**HISTORIC ARCHITECTURAL REVIEW BOARD
FINAL REVIEW SHEET
March 12, 2019**

ITEM #1 – Case #HDC-2019-00001– Proposal to retain the demolition and reconstruction of the side porch of the house.

Property located at: 809 W. Turner Street
Agenda #1
Historic District: Old Allentown
Case # HDC-2019-00001
Meeting date: March 4, 2019

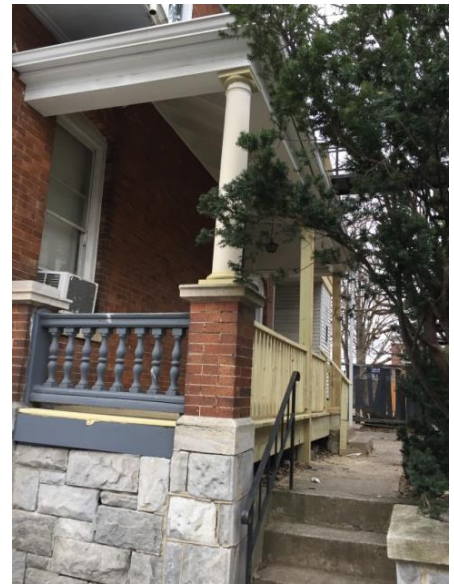
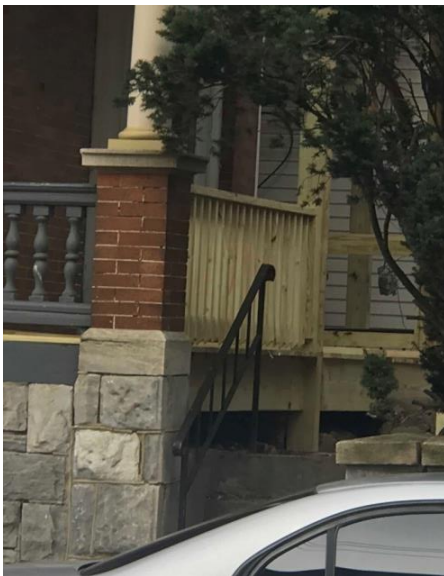
Evaluation, effect on historic district, recommendations: The removal of the balustrade, brick piers, and Tuscan columns is not historically appropriate and has negatively impacted the building. The piers and columns did not appear to be in deteriorated condition, nor does it appear that their removal to replace the floor and floor structure was necessary. This side porch is a character defining feature that should be restored. The columns could be composite material instead of wood but the dimensions must match the remaining wood column. The brick should match the existing iron spot brick as closely as possible.

The replacement of the wood deck with wide deck boards is also not historically appropriate. The porch floor should be replaced with T&G 3" wide fir porch decking and painted or with historic looking composite decking such as Aeratis's Traditions T&G product.

1. The proposal to retain the demolition and reconstruction of the side porch of the house at 809 W Turner Street was represented by Tom Russotti.
2. The existing non-historic porch posts and decking will be removed and the porch reconstructed to match its original historic appearance. This work will include the reconstruction of brick piers with salvaged brick and stone elements, installation of composite material columns matching the historic in dimension and style, installation of 3" wood T&G porch decking or composite decking by Aeratis (or equivalent), and installation of new railings/guards replicated to match remaining historic railing/guard on the front.
3. The brick, balusters, columns and decking choices and details must be submitted to Mr. Kimmerly for approval.

4. Lime based mortar must be used to construct the porch piers. Information on appropriate mortar formulas and pointing is available in Preservation Brief #2 and must be followed.
5. The project must be completed by May 31, 2019.
